Review of Navigation Safety in Wellington Harbour Entrance Channel and Approaches

By South Maritime Solutions for Greater Wellington Regional Council and CentrePort Limited

Final Report - Review of Navigation safety Wellington Harbour Entrance

Figure 3
Diagrams from Schedule 6 to Navigation Bylaws

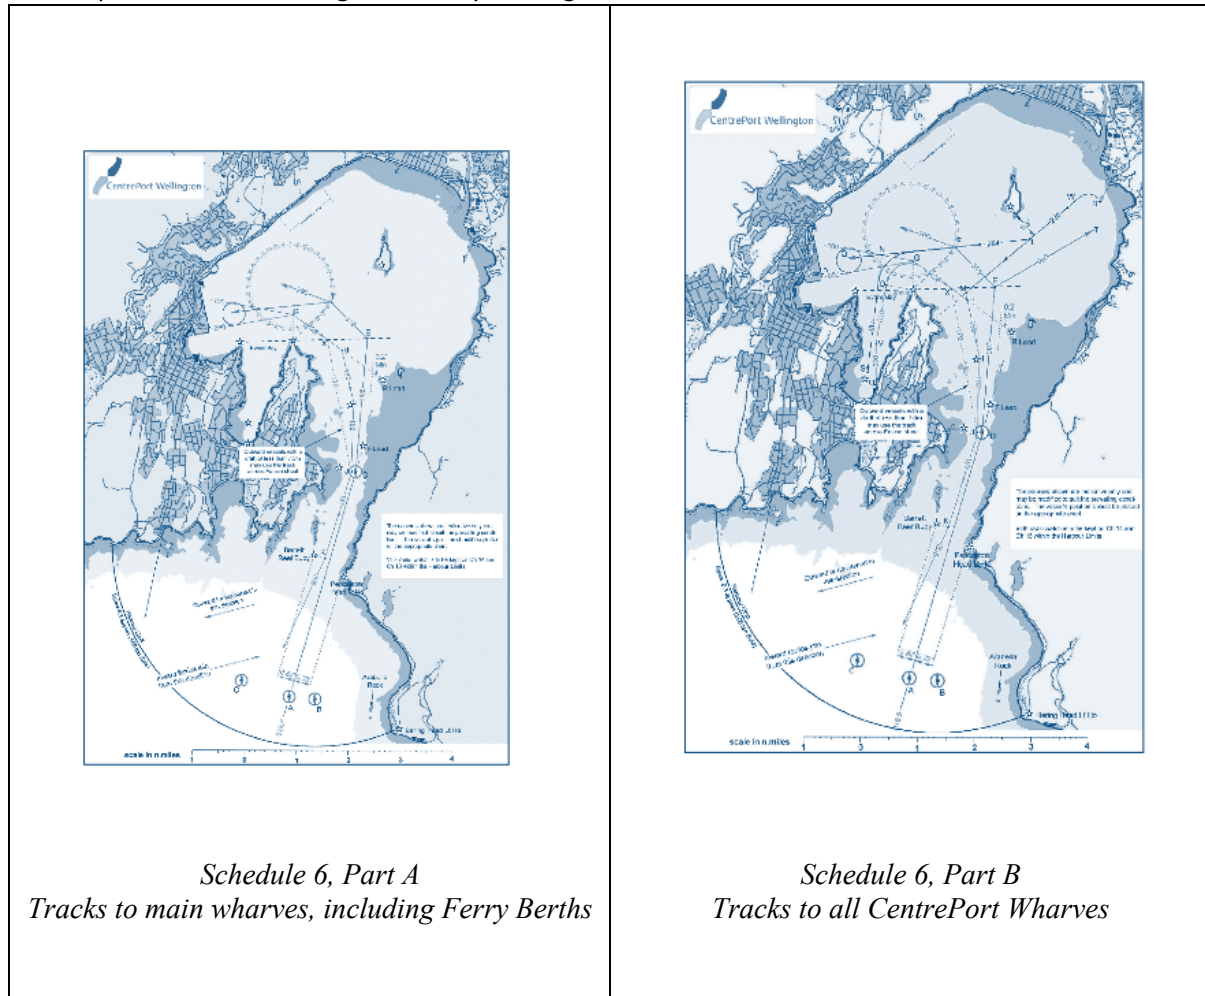
Schedule 6 of the current Navigation Bylaws is titled 'Recommended Tracks' and is split into Part A and Part B. Part A is a diagram showing recommended tracks through the Entrance Channel and then on to '*Tracks to Main Wharves, including Ferry Berths*'. Part B is a diagram showing the same recommended tracks through the Entrance Channel and then on to '*Tracks to all CentrePort Wharves*' (see Figure 3). Schedule 6 also contains a list of all 'Wellington Pilotage Waypoints', which correspond to the recommended tracks described within the Navigation Bylaws.

The notation on the chart does not delineate between those recommended tracks contained in Part A or Part B of Schedule 6; it simply refers to 'recommended tracks' in Schedule 6.

However, the 18-metre rule only refers to tracks shown in Part A. Section 6.1 of the Navigation Bylaws describes '*Directions for Transiting Wellington Harbour Entrance*'. Paragraph 6.1.4 requires all vessels over 18 metres in length to follow only the tracks shown in Part A of Schedule 6¹³ (those tracks to the main wharves and ferry berths).

For these reasons, and those discussed in the following sections, we are recommending that the recommended tracks be removed from the Navigation Bylaws. If they are to remain then these anomalies will need to be rectified and the intent of the recommended tracks fully and clearly explained for the benefit of all harbour users.

Extract from Chart NZ4633 showing inward tracks highlighted in red and outward tracks in green

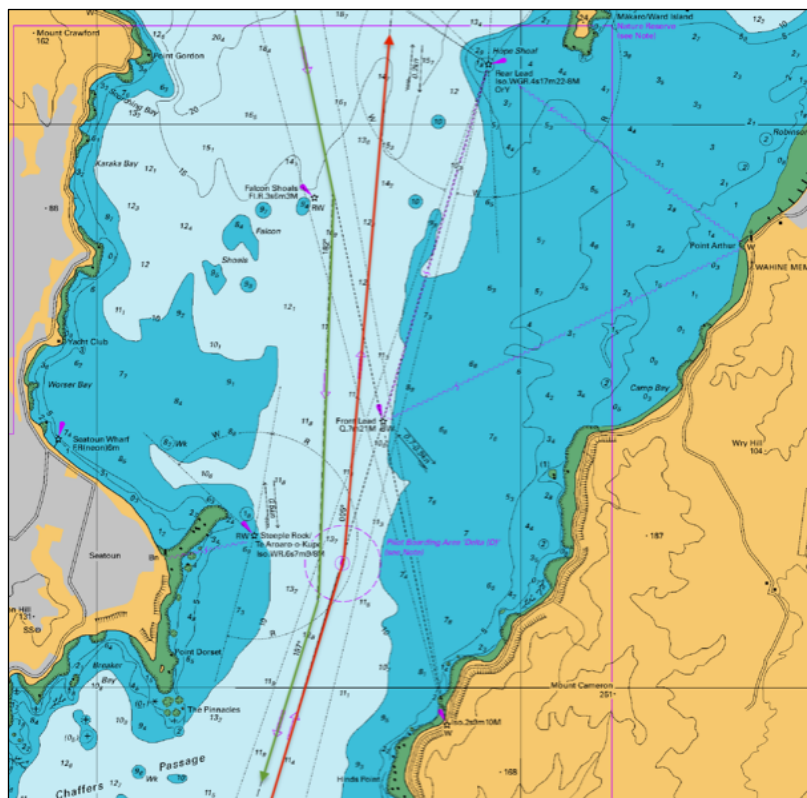
Figure 4 shows the recommended tracks for the Entrance Channel published on Chart NZ4633. The inbound bound tracks have been highlighted in red and the outbound tracks in green. The tracks converge to a minimum distance between them of 75 metres just south of Steeple Rock, and then open slightly to 120 metres off Barrett Reef Buoy to the south and to 280 metres off Falcon Shoal to the north.

Ships with an excess of 25 metres beam frequently transit the Entrance Channel with a combined closing speed of up to 40 knots. Two ships at a 25-metre beam passing off Steeple Rock, and on the recommended tracks, would pass with a 50-metre closest point of approach (CPA), which leaves little margin for human error or mechanical failure. The credible consequences of a ship collision or grounding in this area would be high.

Most of the pilot exemption certificate (PEC) masters and pilots consulted expressed concern at passing another ship in this area with such small margins, and some even expressed concern at passing large ships elsewhere in the channel between Steeple Rock and Barrett Reef Buoy. Some were also uncomfortable passing ships in the area off Falcon Shoal, particularly as outbound and inbound ships approaching it can be on a collision course leading up to a course alteration by the outbound ship off Falcon Shoal Beacon. Pilots and masters generally alleviate the perceived risk by either adjusting speed to avoid passing in the narrows or deviating to starboard to increase the passing distance.

There is sufficient sea room to alleviate, if not remove, the doglegs that currently exist around the Falcon Shoal and Steeple Rock area, particularly if the concept of a controlled navigation zone and marginally offset inbound and outbound tracks were to be adopted. Also, the waypoint-to-waypoint style of the recommended tracks is no longer consistent with modern passage planning, which allows for controlled turns to 'ease' onto the next course. We discuss these concepts in the following sections.

- 4 That the recommended tracks be reviewed and amended as appropriate to correspond with any other actions arising from this report.
- 5 That regardless of what other actions are adopted, the recommended tracks be reviewed to alleviate or remove unnecessary doglegs and facilitate the controlled turn method instead of an abrupt waypoint-to-waypoint method.

Extract from Chart NZ4633 showing potential conflict between vessels near the pilot boarding grounds

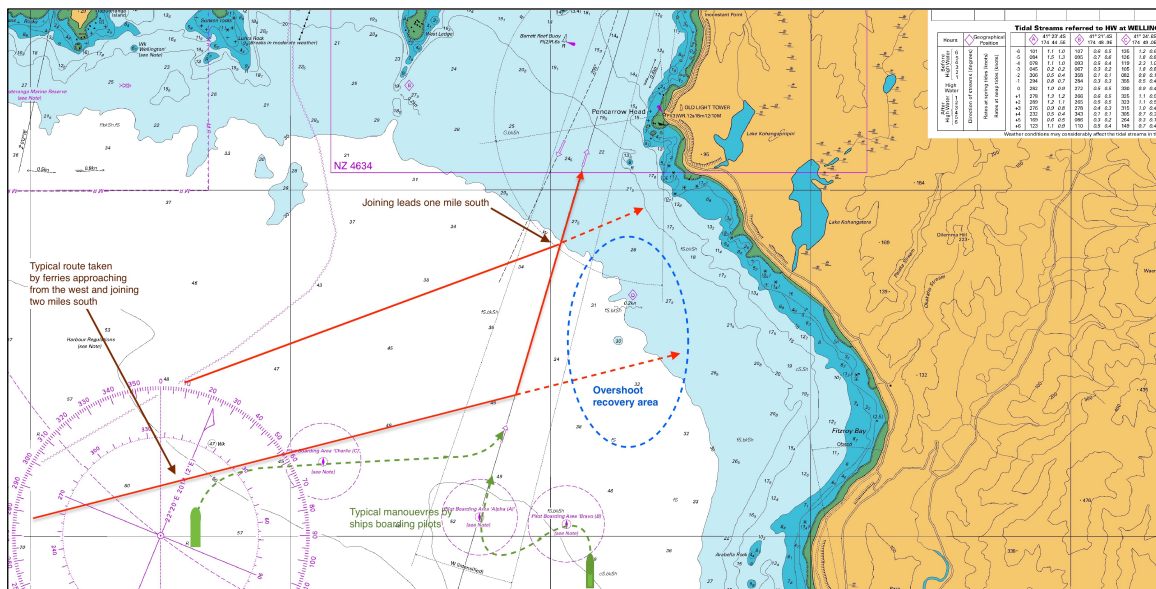
Alpha, Bravo and Charlie pilot boarding areas are used variously by the pilots, depending on vessel traffic and weather conditions. In the main Bravo, to the east of the line of leading lights, is used in easterly or fresh southerly wind conditions, or when required to separate outbound traffic or inbound traffic approaching from the west. Alpha, on the line of the leading lights, is used in light wind conditions. Charlie, west of the line of the leading lights, is used in northerly and southerly wind conditions but is the most used pilot station for northerly conditions, which is the prevailing wind (see Figure 6).

We also question the need for three pilot boarding areas, particularly if they are all moved southward to the harbour limit. Anecdotal evidence suggests that arriving ships can be confused by a direction to proceed to a particular pilot boarding area. It is not until they zoom in on the Electronic Chart Display and Information System (ECDIS) that the delineation between them becomes clear. Even then, the three boarding areas seem to be in no particular order, left to right versus right to left. Alpha is on the leads, Bravo is to the east and Charlie is to the west.

- 3 The third is to foster a culture of planning ahead, so there is a requirement that could be imposed for those with the conduct of each ship to communicate their intention to each other, rather than adopting the dangerous practice of making assumptions on what will happen next. This will require a coordinated approach involving CentrePort and the various pilot-exempt ship operators, possibly with the need to mandate the practice through Navigation Bylaws. This option should be considered regardless of Options 1 and 2.

Figure 7
Extract from Chart NZ4633 showing example of side leads

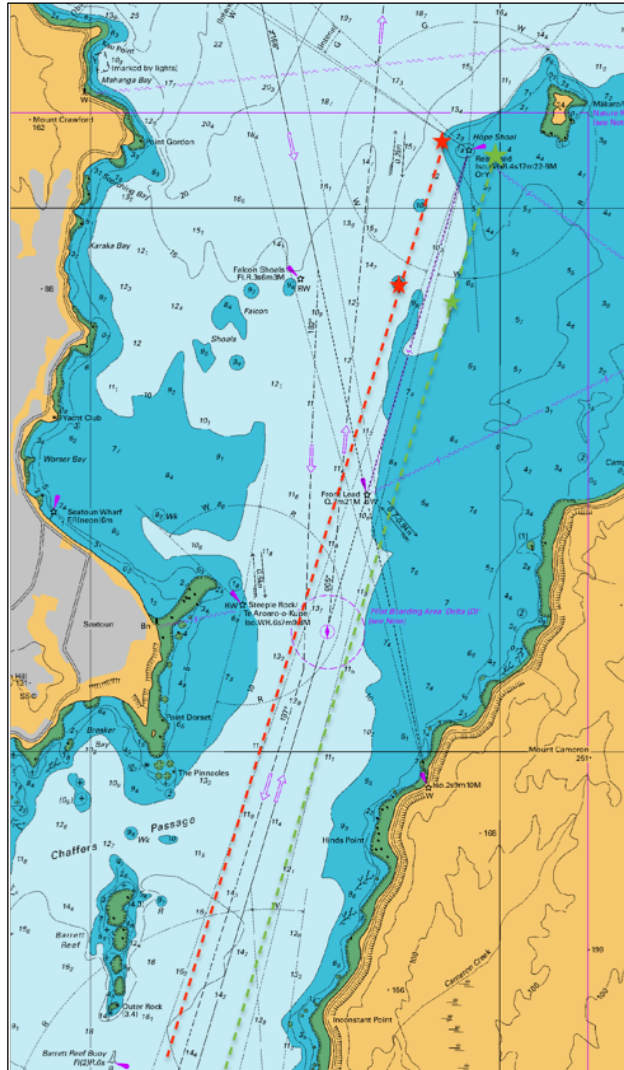
It might be feasible to install sets of parallel port and starboard leading light beacons either side of the main leading lights (see Figure 7 for an example), or to adjust the configuration and characteristics of the existing leading light beacons to provide the same effect.²³ This would provide an additional visual reference either side of the main leads to better indicate how far displaced a ship is from the main leads. It would have the added benefit of providing alternate leading lights near the extremities of the navigable channel for small shallower draught vessels to use, rather than them using the main leads and risk impeding the passage of large vessels, particularly at night.

Annotated extract from Chart NZ4633 showing a broad concept of how a controlled navigation zone and associated recommended tracks in the Wellington Harbour Entrance Channel could look

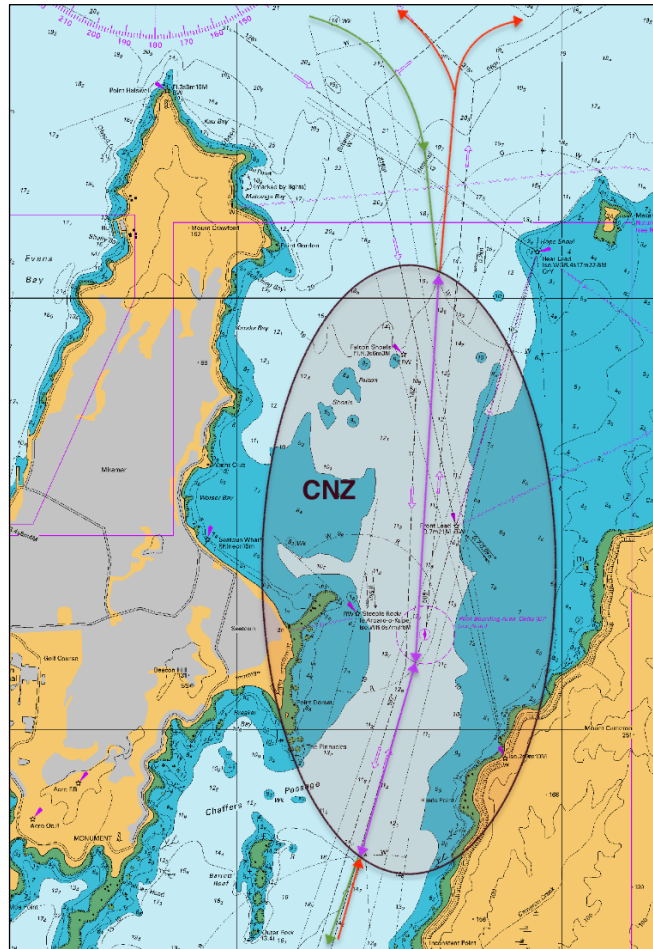
Figure 8 shows an example only of how a controlled navigation zone and associated recommended track could look. Obviously, the detail would need to be worked through using the experts who will oversee and use the system.
